Waiver Requests for Plan Entitled

Proposed Plan of Lots
45 Beacon Street
Prepared by
GA Consultants
March 17, 2022

PLAN SET:
**MAJOR SITE PLAN MODIFICATION
GRANDVIEW ROAD SUBDIVISION - PRIVATE WAY
(GRANDVIEW ROAD EXTENSION)**
SITE PLAN PERMIT SET

To: Andrew MacNichol, Community Development Director
From: Alex Rozycki, P.E., Senior Civil Engineer
CC: Ryan A. Percival, P.E., Town Engineer; Mary Benedetto, Senior Planner
Date: April 27, 2023
Re: Grandview Road Extension

JOB NO.: 20160-149
SHEET TITLE:
GRADING AND DRAINAGE PLAN
SHEET NUMBER:
 C-4

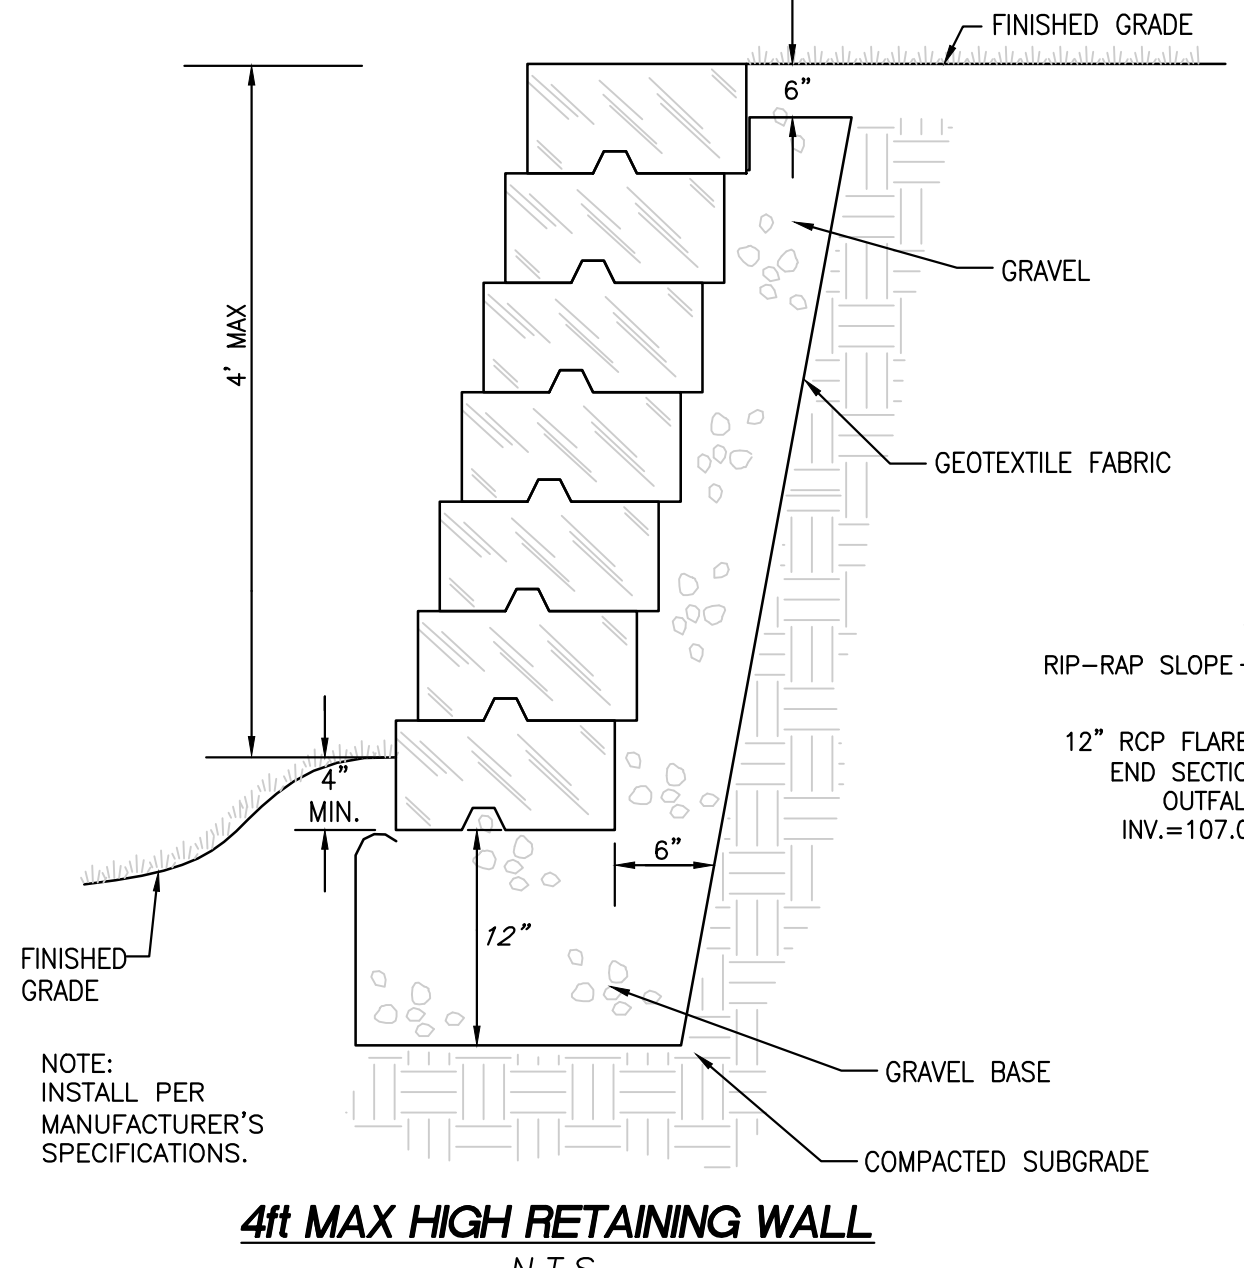
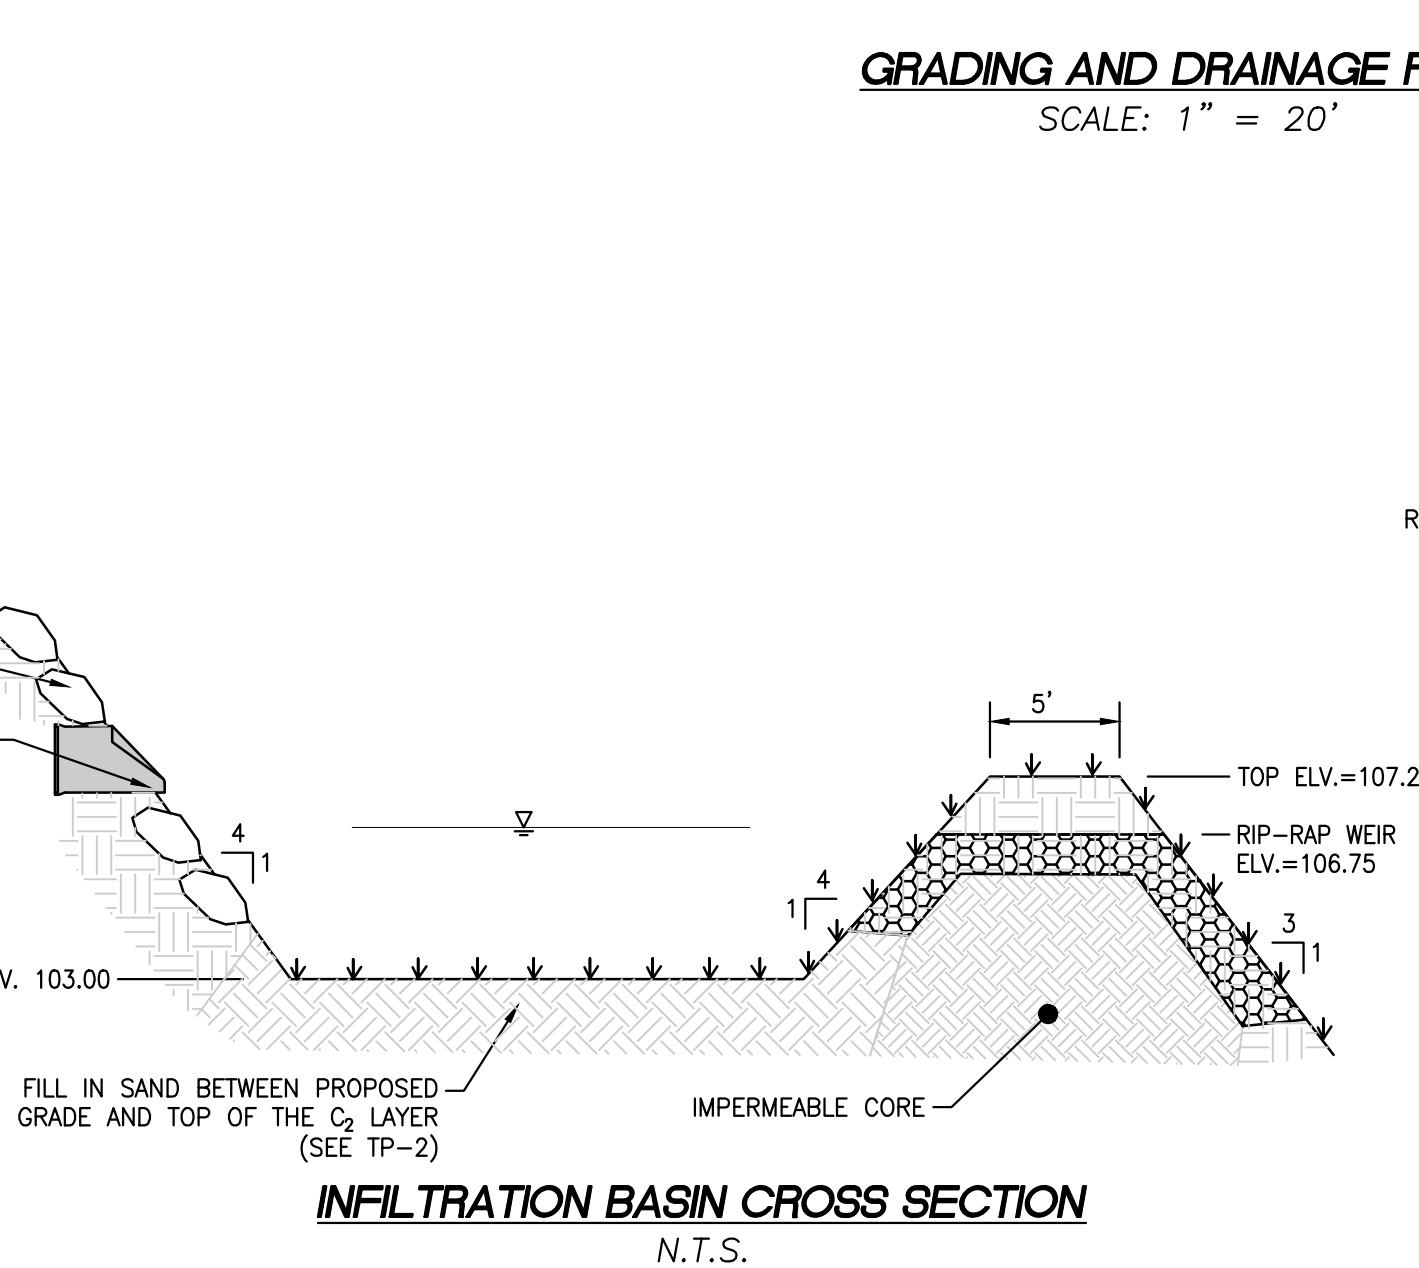
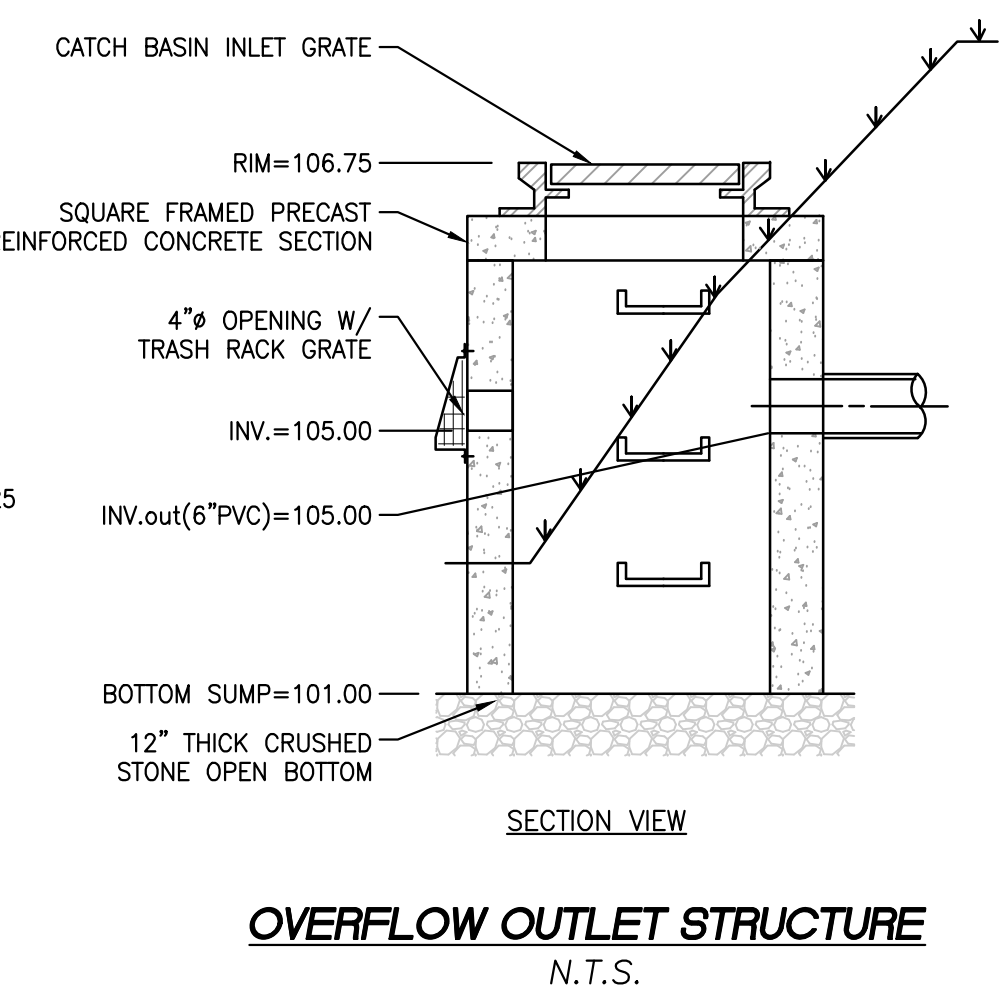
- Previous plans for the southernmost home included roof drainage tied into the infiltration system, there are concerns that the adjacent property will now receive stormwater flows given the grades. The stormwater report indicates all impervious area will be captured, does that include hardscapes on the lots? The previous plan captured impervious areas on individual lots.

- The infiltration chamber design under the endorsed plans will allow for more land use in the backyard areas, the proposed detention pond design eliminates the use of land.

JOB NO.: 20160-149
SHEET TITLE:
 UTILITY + ROADWAY PROFILE PLAN
SHEET NUMBER:
 C-5

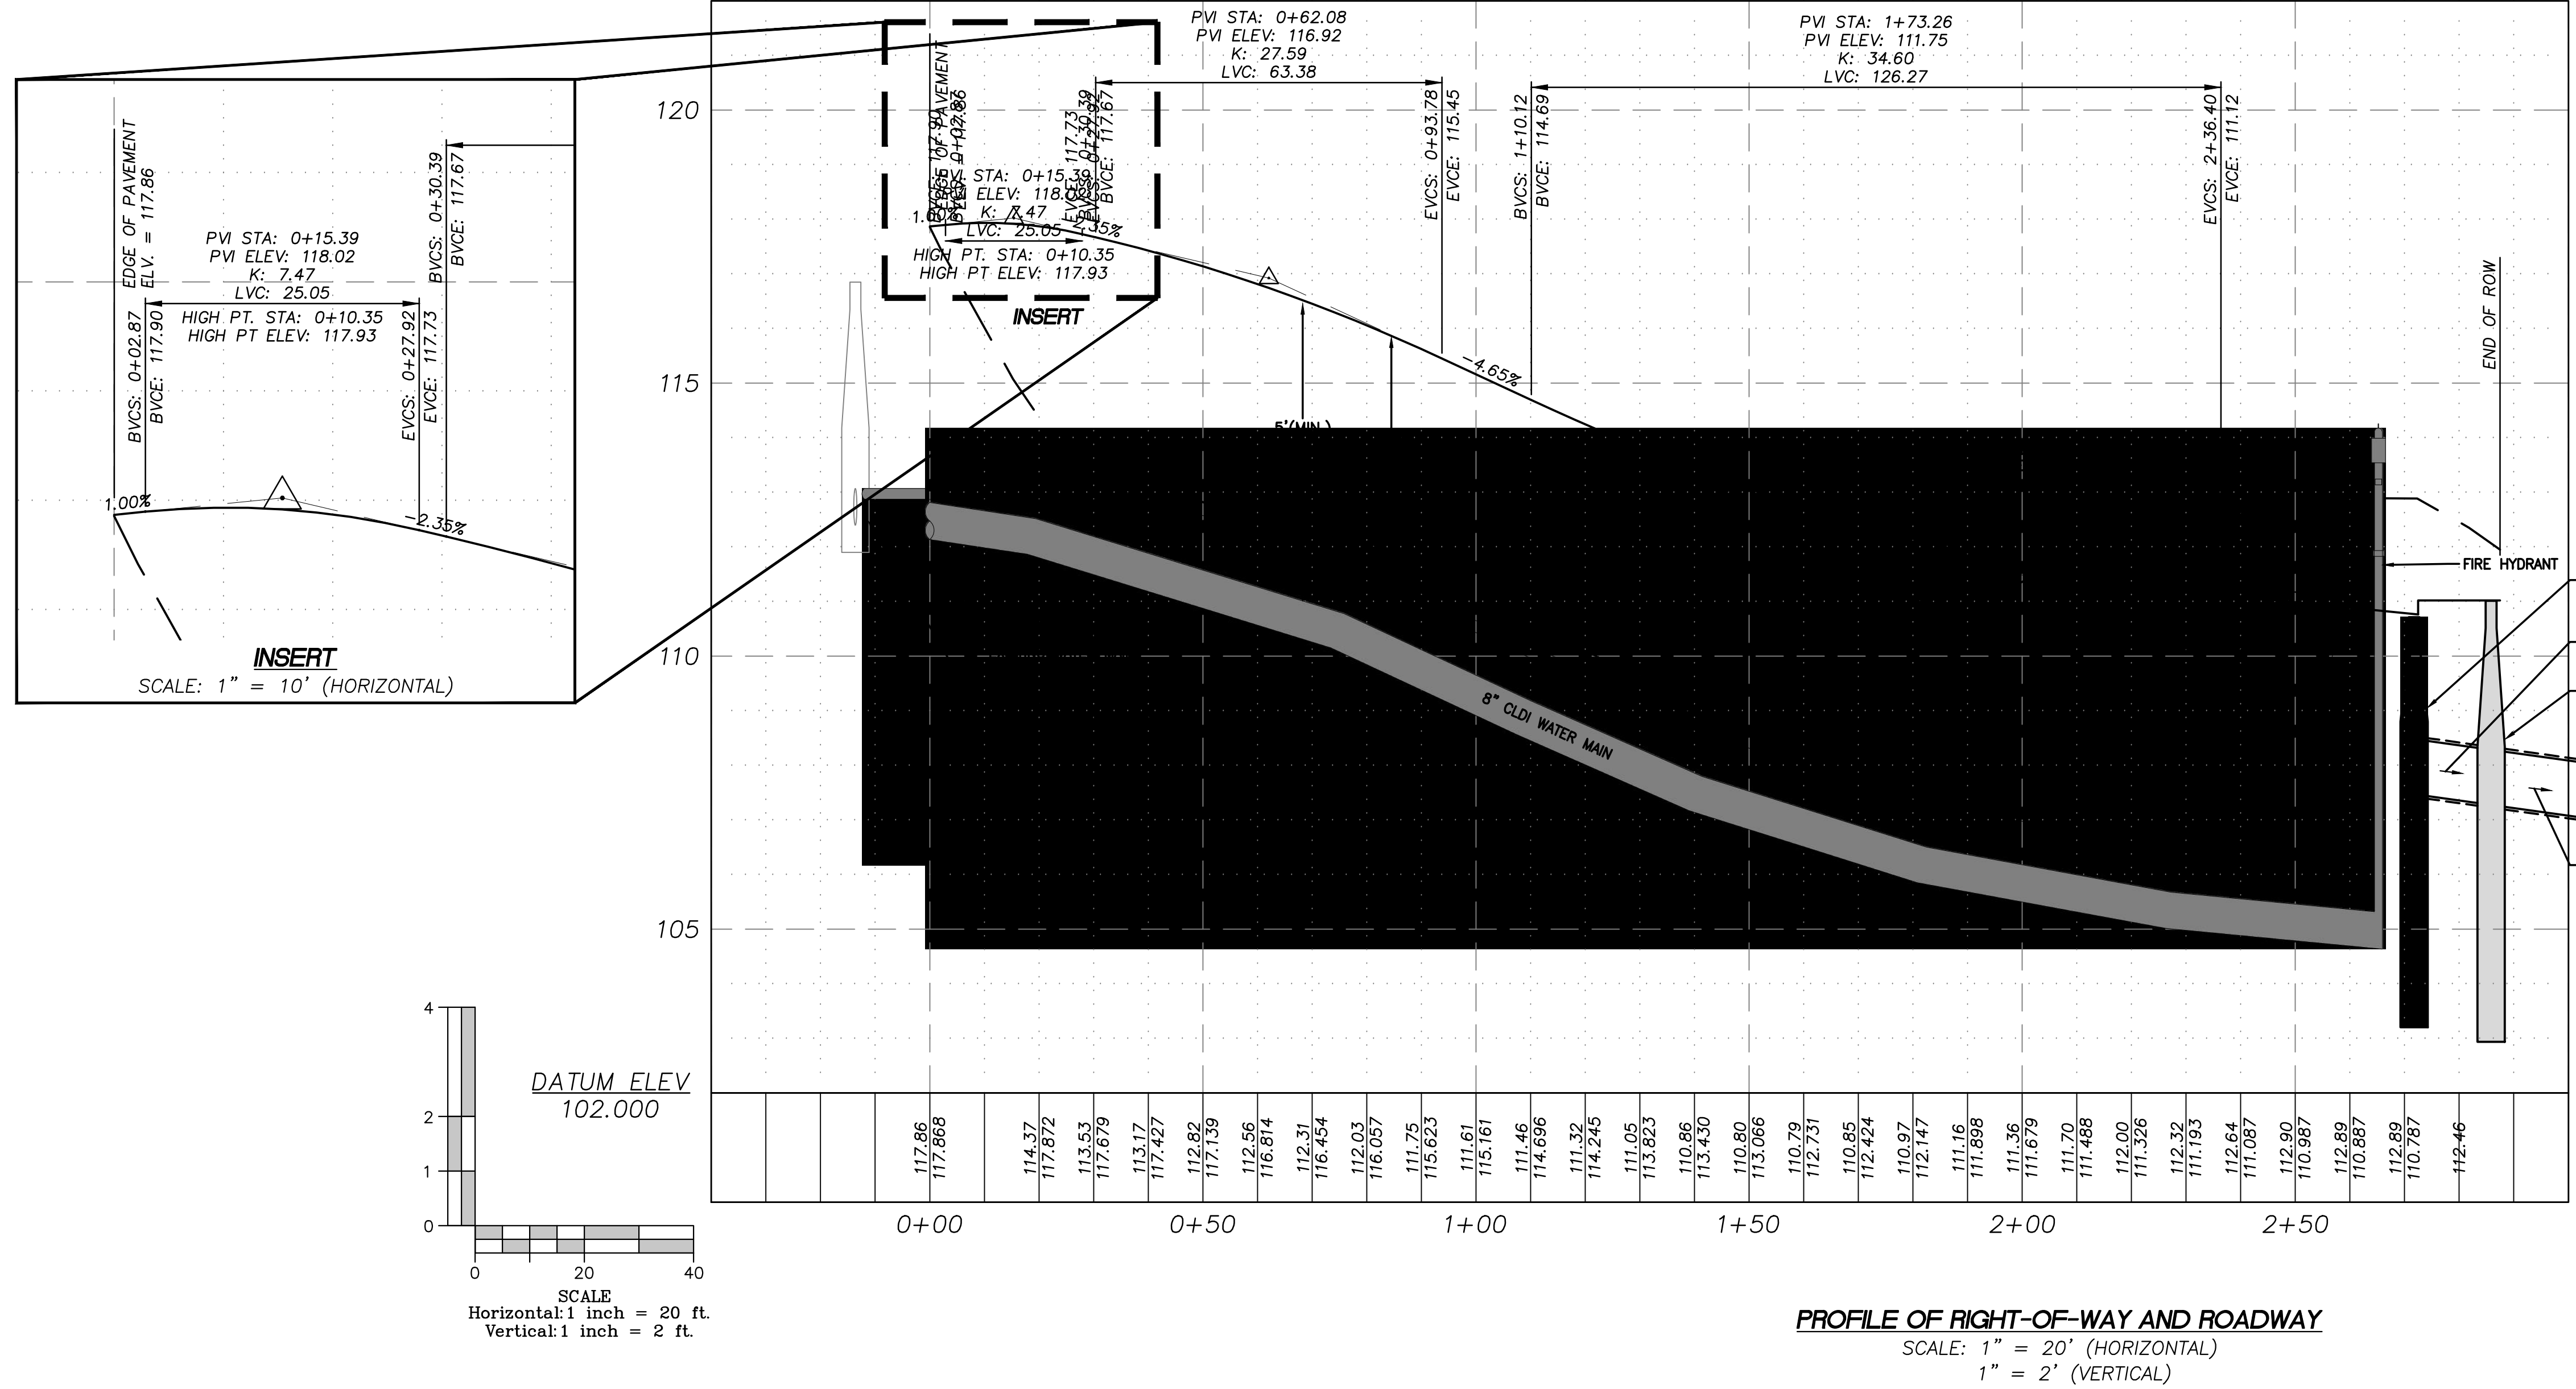
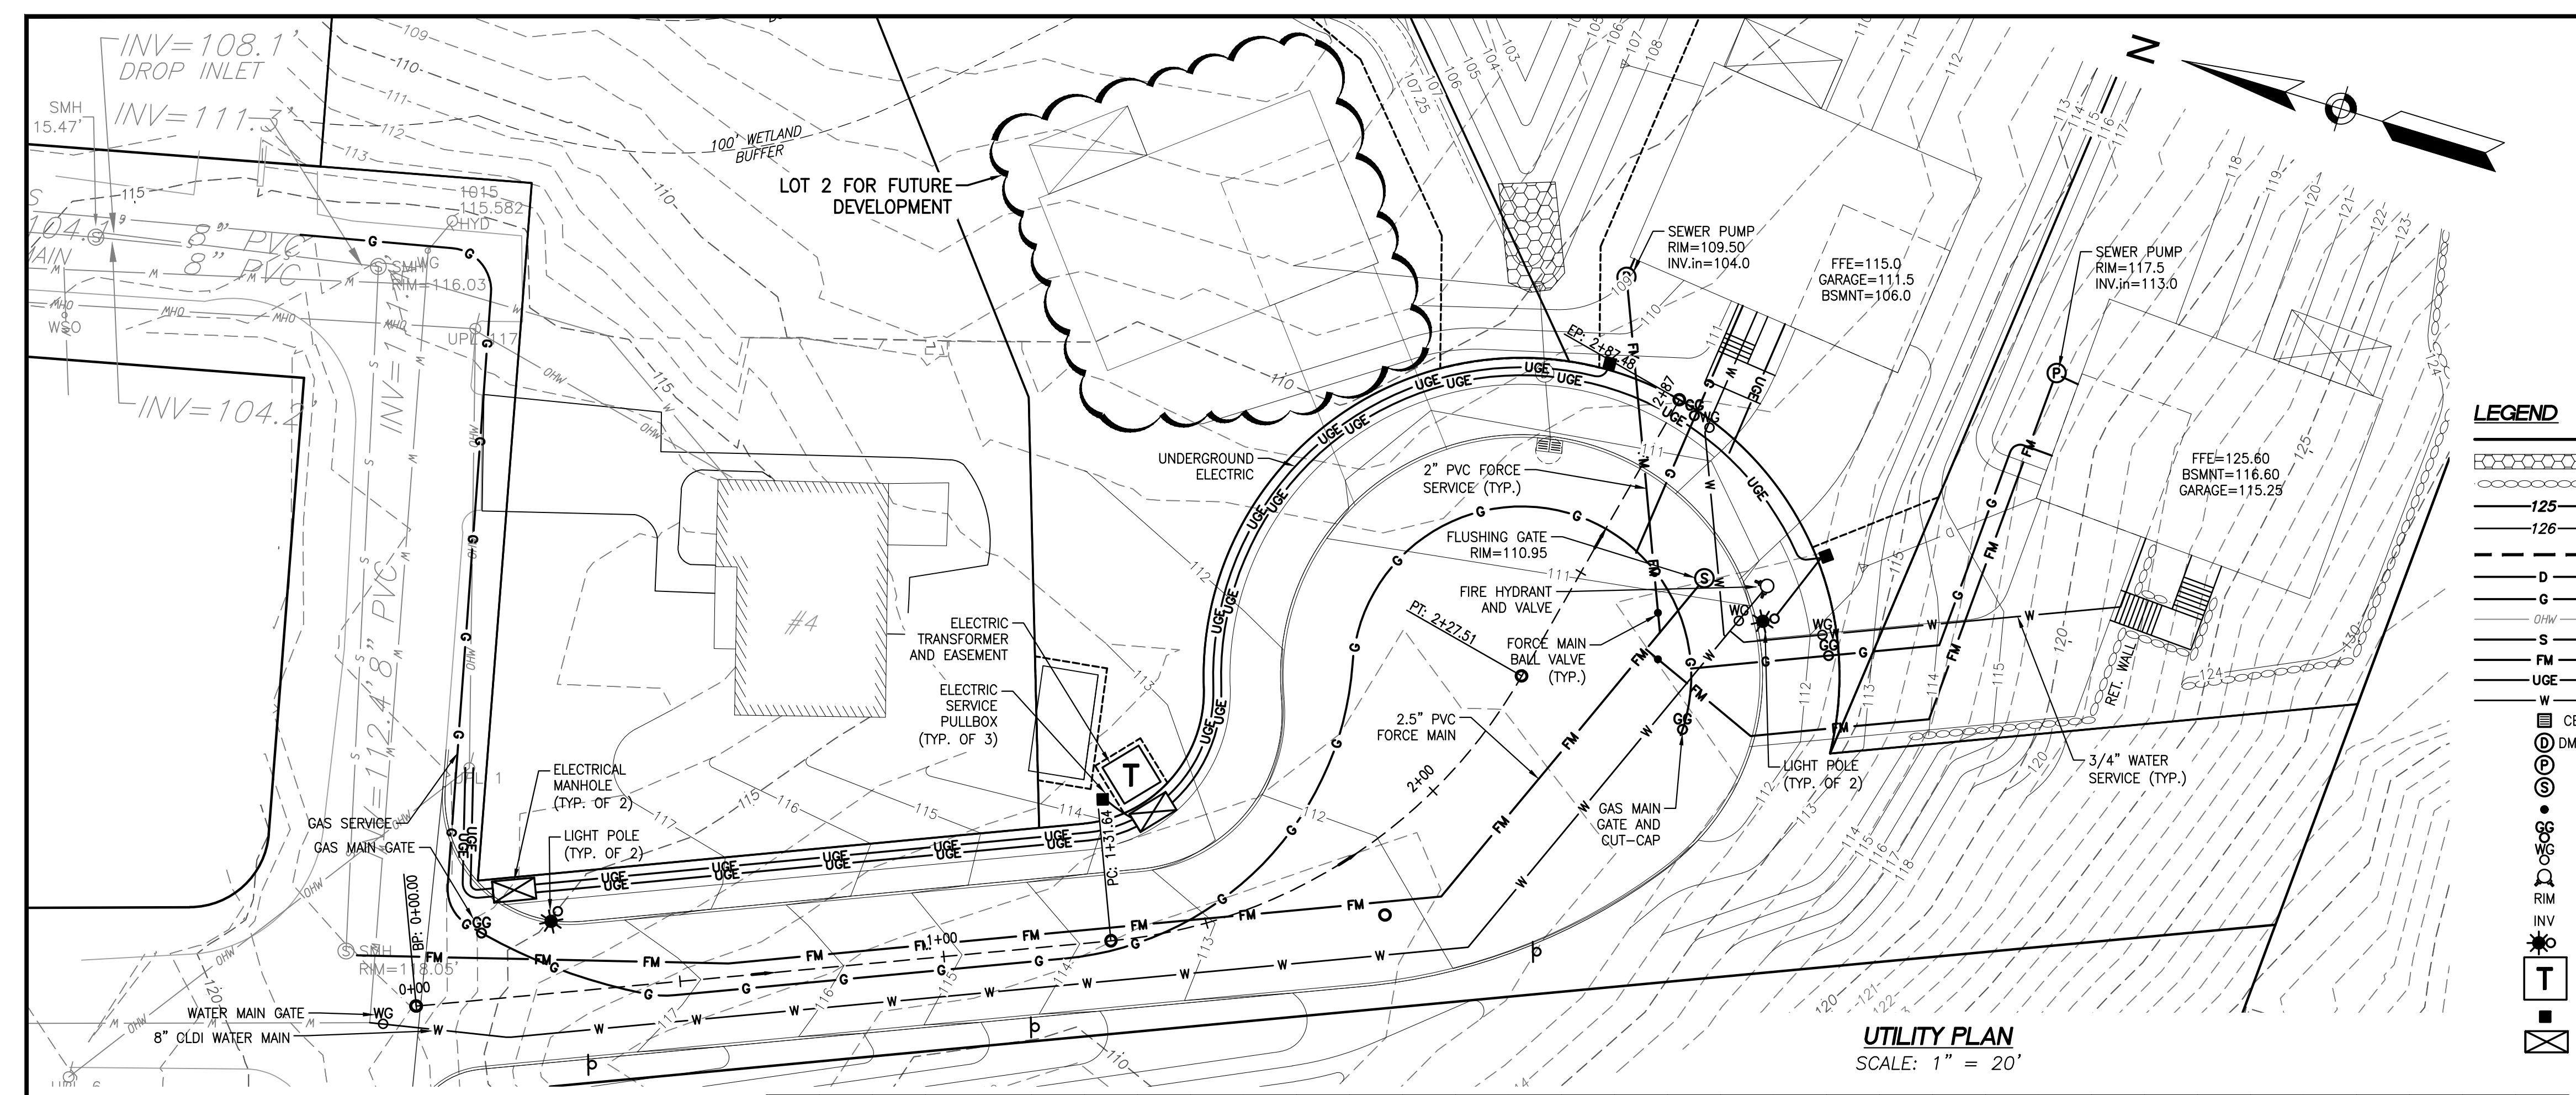
- Inverts of the existing sewer manhole should be provided, as well as a detail for the force main connection.
- MaDEP regulations may not allow for discharge of water or overflow rip-rap within 10 feet of a property line.
